AMENDMENT OF SOLICITATION/MODIFICATION OF CONTRACT

(X) ☒ 9A. AMENDMENT OF SOLICITATION NO. N00173-14-R-VH02

This amendment is being issued to address questions received in response to the solicitation. The response time to the solicitation has been extended to 12:00 noon, EST on 18 JuL 14.

Questions and Answers
RFP N00173-14-R-VH02

SOLA
SOLA
Big Blue
PLCs

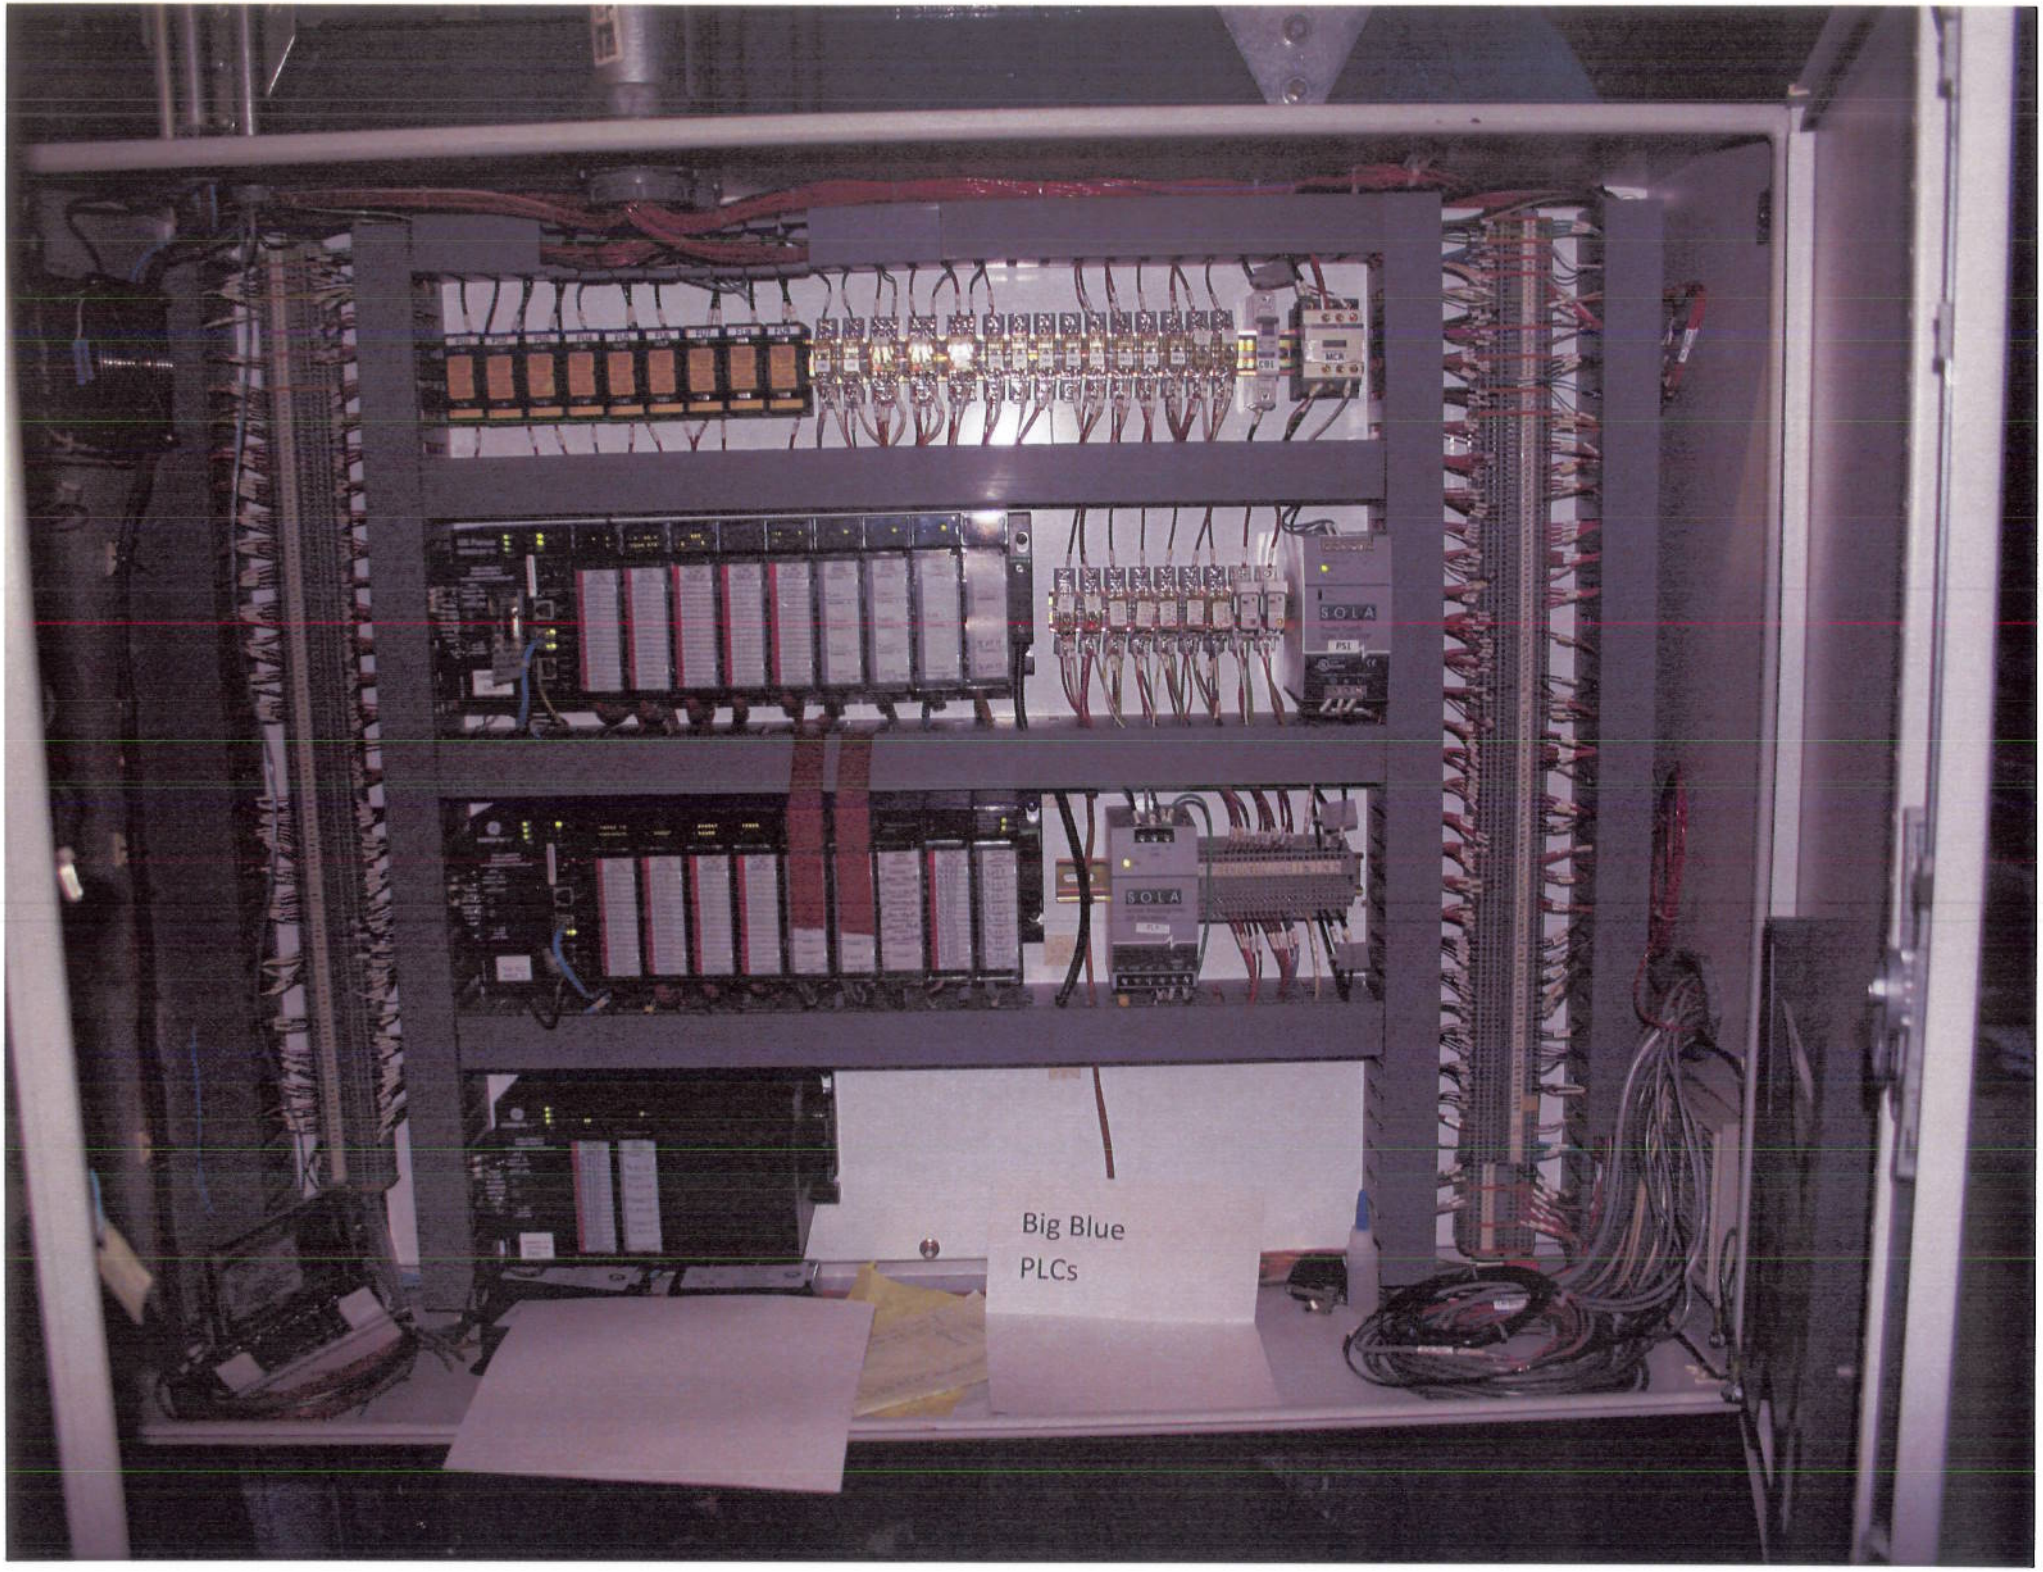
Q: Are there photographs of the existing panels available?
A: Yes, Photo's of the PLC cabinets are attached..

procidia
MOORE
Procidia
PLCs

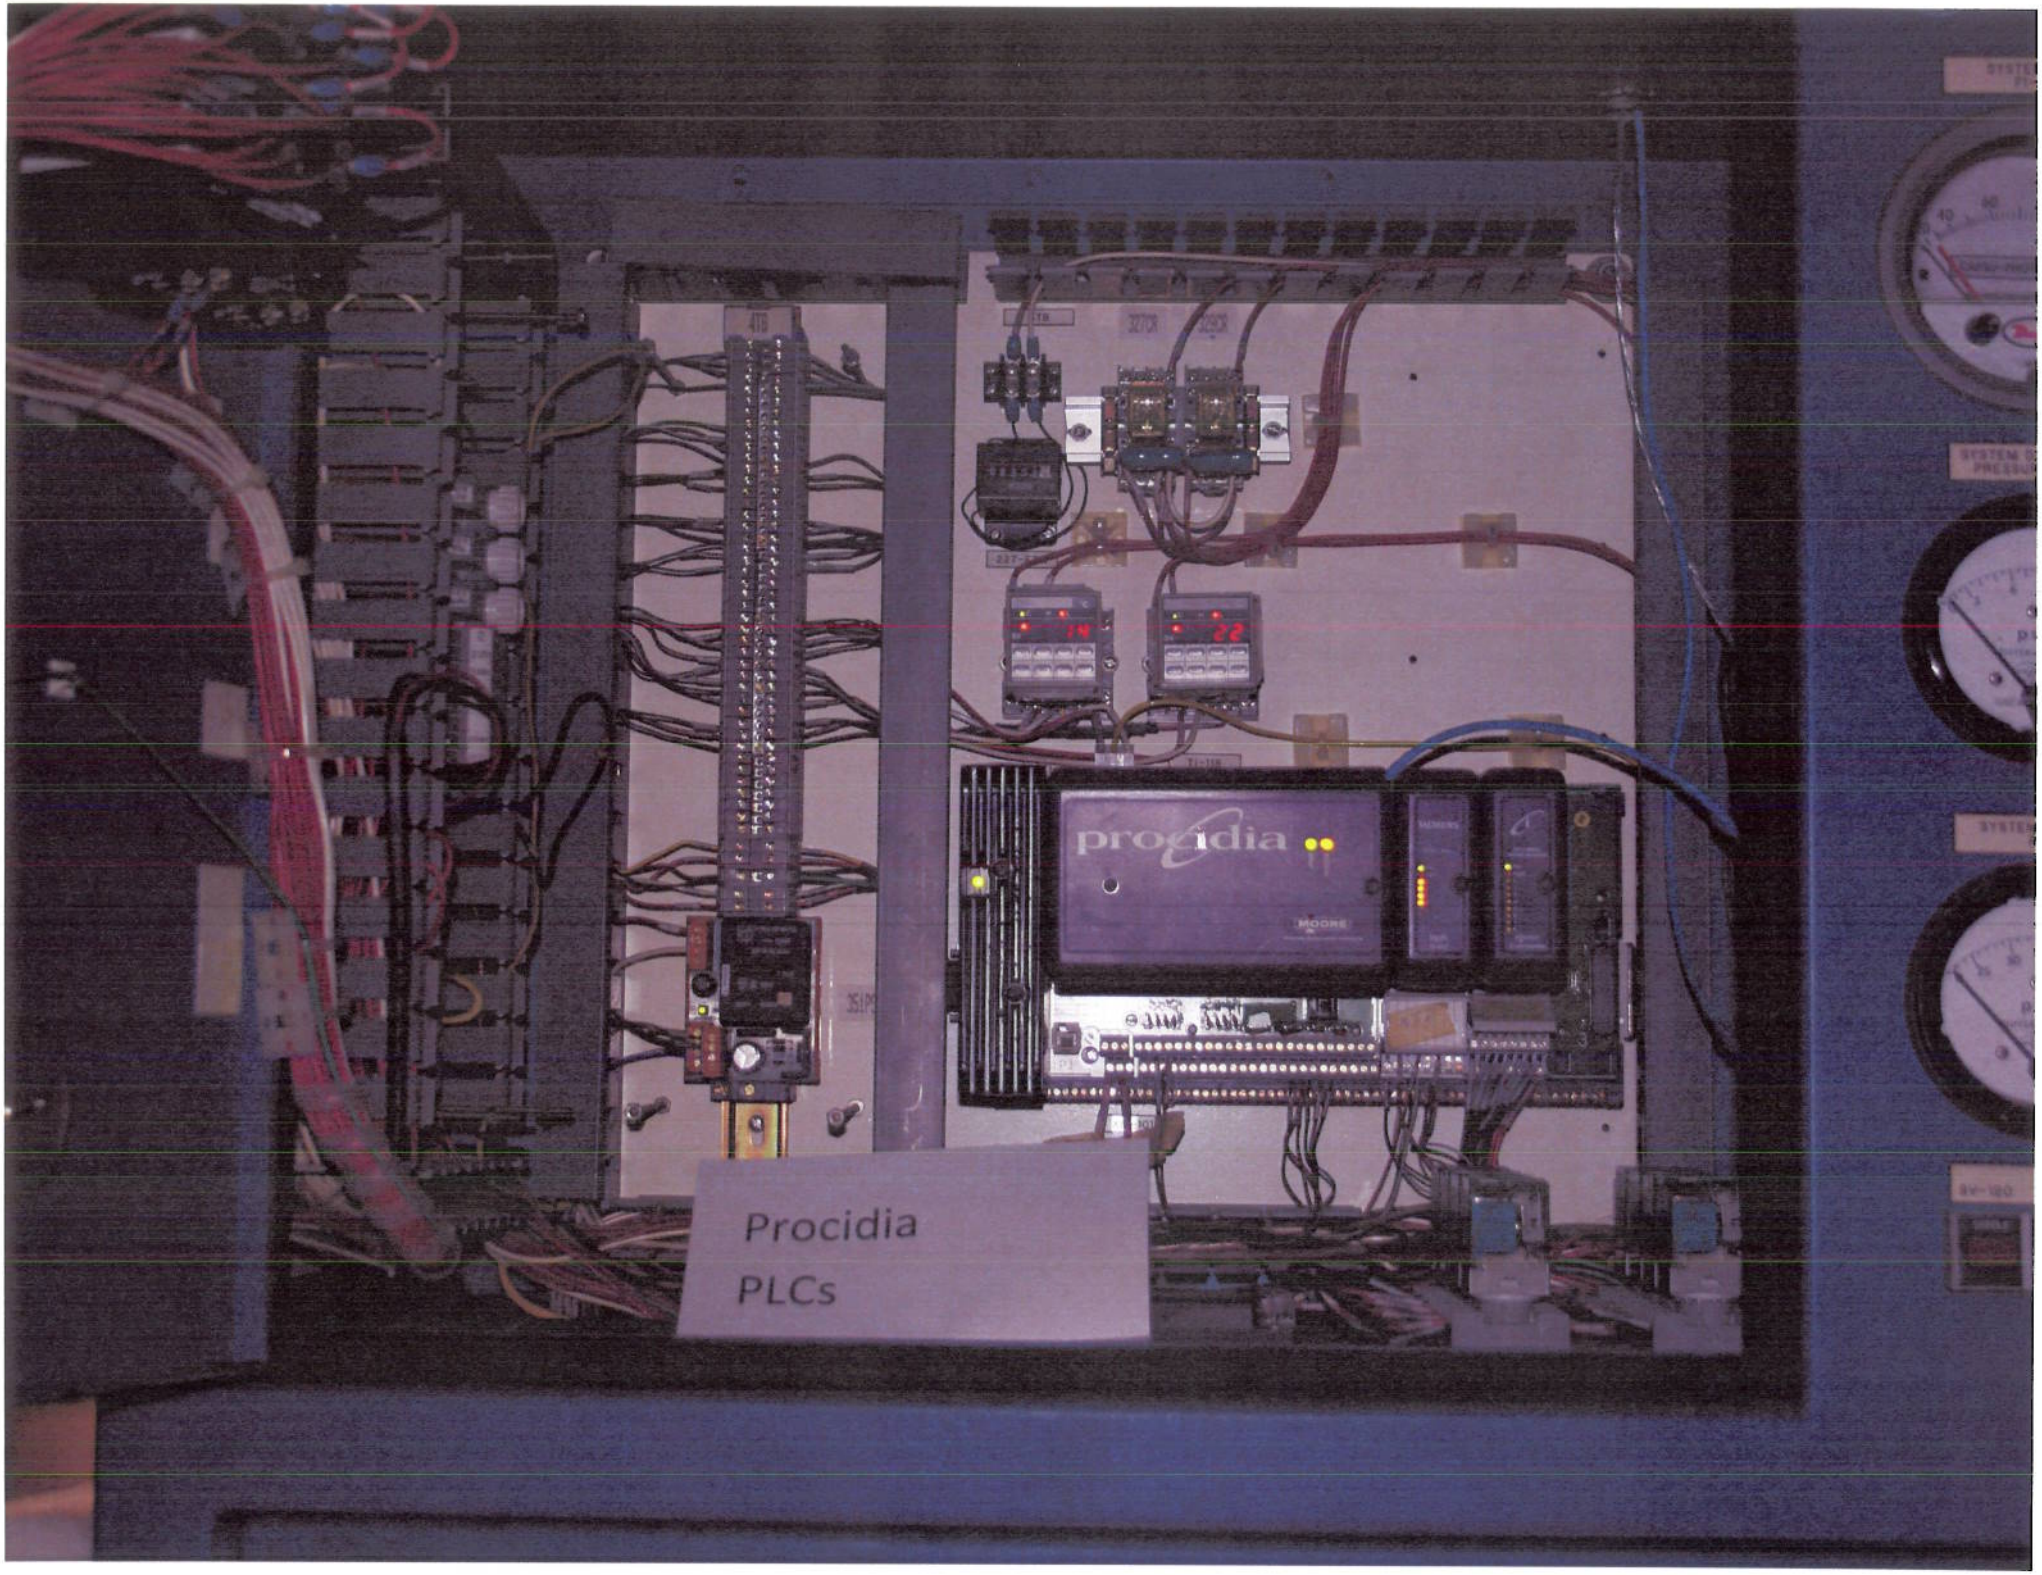
Q: On the site plan on page 14, it looks like the Big Blue TVAC and TCU PLC's and the North and South PLC's are located together, were is the Procidia PLC panel?
A: The Big Blue TVAC and TCU PLCs are located in a common cabinet at the North West corner of Big Blue. The North chamber and South chamber PLCs are located on the West wall near the two chambers. The Procidia PLC is located in the TCU it controls which is in the Pump room just to the west of the Big Blue PLCs.

Q: Is there a Procidia PLC panel drawing?
A: Yes. Drawings for the TCU that contains the Procidia controller are attached.
